MSG Sphere, Land off Angel Lane, Stratford

Local Planning Authority reference 19/00097/FUL

Strategic planning application stage 2 referral

Figure 3-1 - Examples of spill light representation extracted from Chapter 11

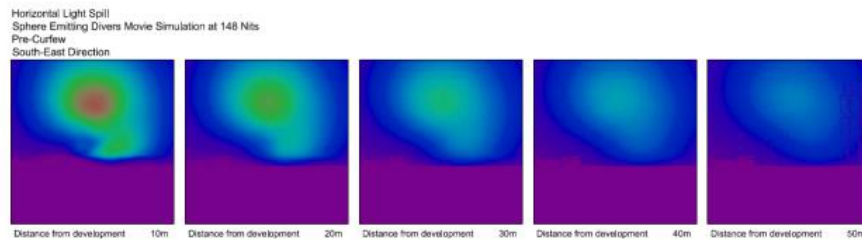
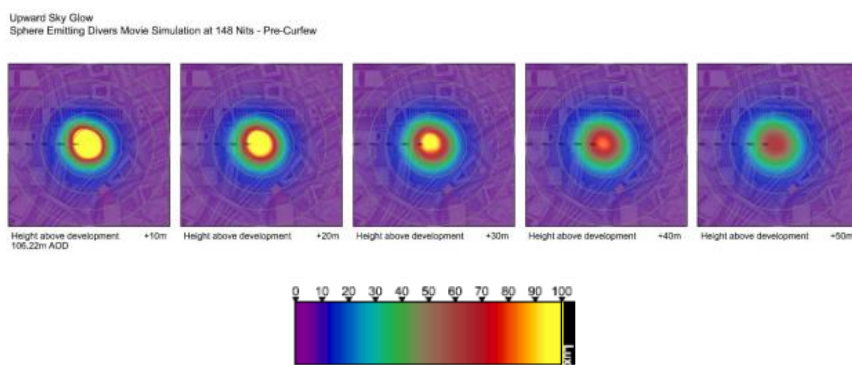
- 3.3.5. Both these figures indicate that the display is set to the same output of 148 NITS (cd/m^2) the grids are the same distance apart, 11.17 being vertical illuminance and 11.18 being upward illuminance assessments. It is appreciated that the vertical assessment is not the full sphere but the vast difference in illuminance at these distances for the same setting does not seem right. More light is being emitted upwards than horizontally. Grid sizes may be different, but the central assessed illuminance should be similar.

- 3.3.6. It is stated¹² that moving image lighting with white pixels emitting 148 and 30 cd/m^2 (nits) would generate lower illuminances than 37 and 7 cd/m^2 (nits) of uniform white light, and thus the latter set of values is used as a worst-case scenario. This comment only applies if there is a small element of white light within the moving display which is the case for the video images used for assessment¹³. This can't be guaranteed, if the video image has a high proportion of white light content at 148 cd/m^2 even for a brief period then this has the potential to impact on the surrounding properties, to a higher degree that if the sphere was set to all white.

Figure 3-2 - Example image of the Five Light Intrusion Sensitivity Zones, extracted from Chapter 11

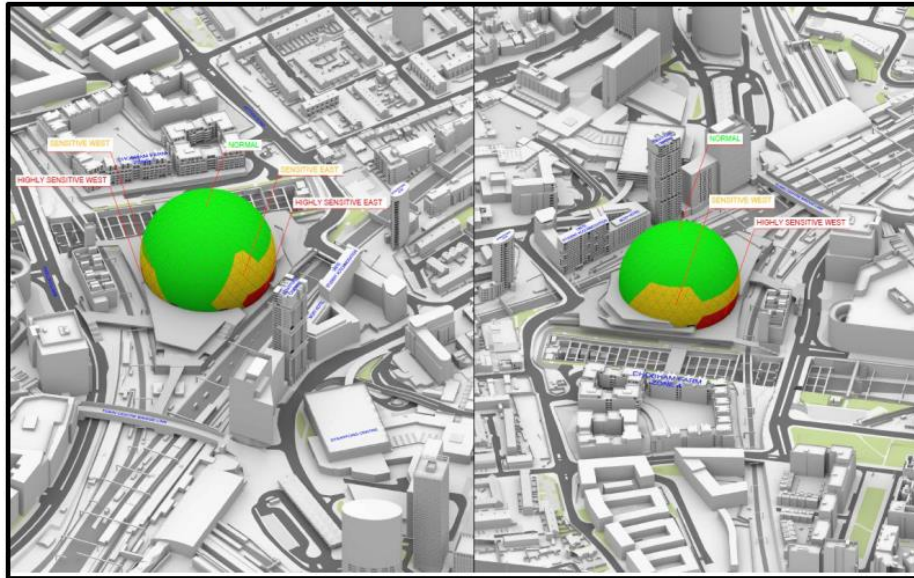
building¹⁸s. Chapter 11 figure 11.3 below shows these zones. The intention being that the digital display performance and output can be set to suit receptors' requirements.

- 3.7.10. We find it surprising that this has not been considered for the upper surfaces of the sphere with respect to all light emitted that has the potential to contribute to skyglow effects.
- 3.7.11. It is stated¹⁹ that no effect scale and significance criteria are applicable to the upward skyglow as the site is within the heart of Stratford and accordingly is in a highly urbanised and built-up area. We consider this is no reason to effectively dismiss the effects of skyglow. The development should comply with the Environmental Zone criteria set out in ILP GN01 for the Environmental Zone in which it is being built.
- 3.7.12. We note the comparison with the adjacent stadium, but such comparisons are of limited assistance, each site should conform to the local requirements and to relevant standards and guidance.
